MEMORANDUM

From:	Chief Officer, Environment & Technical	**To:**	Chief Officer Economy & Planning
		FAO:	Lauren Rawlinson
Our Ref:	ET/DC/DB/P/2026/0485	**Your Ref:**	P/2026/0485
Date:	23/10/2026

PROPOSAL: TROSI ANNEDD YN 2 ANNEDD / CONVERSION OF DWELLING INTO 2 DWELLINGS

LOCATION: 1 HARWD ROAD, BRYMBO, WREXHAM, LL11 5BP

2) The Local Highway Authority limits of adopted highway in yellow as screenshotted below

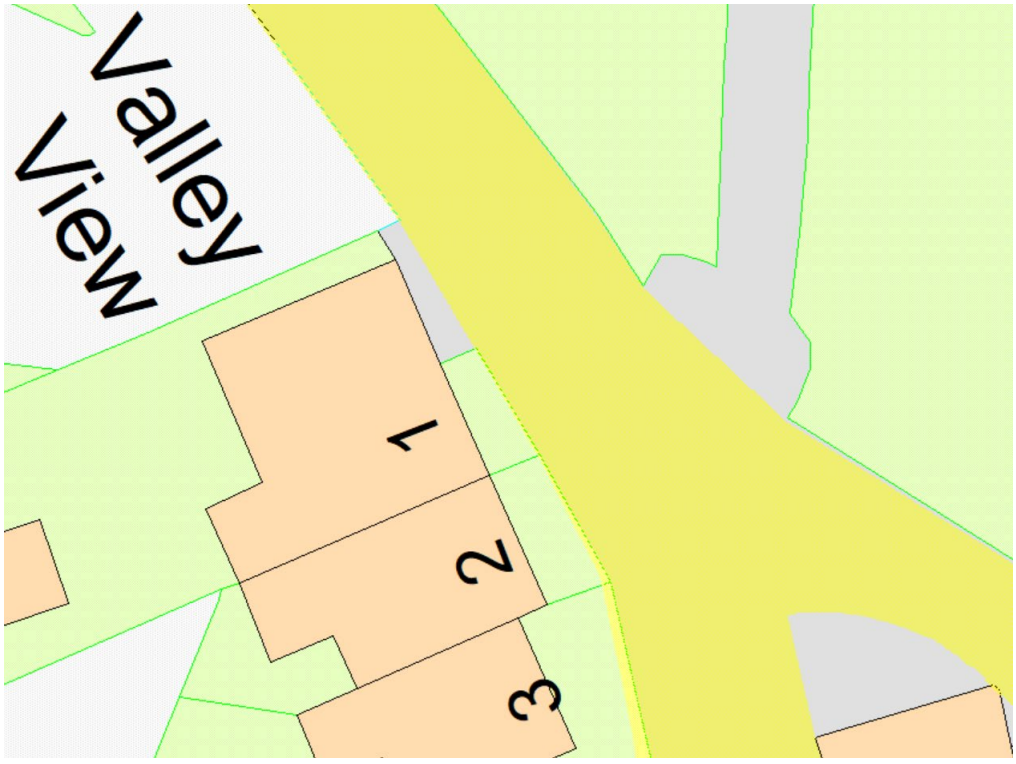
The applicant has suggested that there are existing legitimate roadside parking spaces outside number 1 already. In accordance with highway code guidance (rule243) parking spaces within 10m of a junction is not permitted, so the Local Highway Authority would not accept the spaces drawn as existing recognised roadside parking spaces.

As the existing arrangement cannot be accepted as recognised roadside parking, the proposed parking improvement cannot be supported on this basis.

Furthermore, the submitted plans identify an area of adopted public highway as a private parking space. The use of adopted highway land for private parking purposes is not permitted and therefore cannot be accepted.

Consequently, the Local Highway Authority are unable to support the proposed plans to provide possible parking.
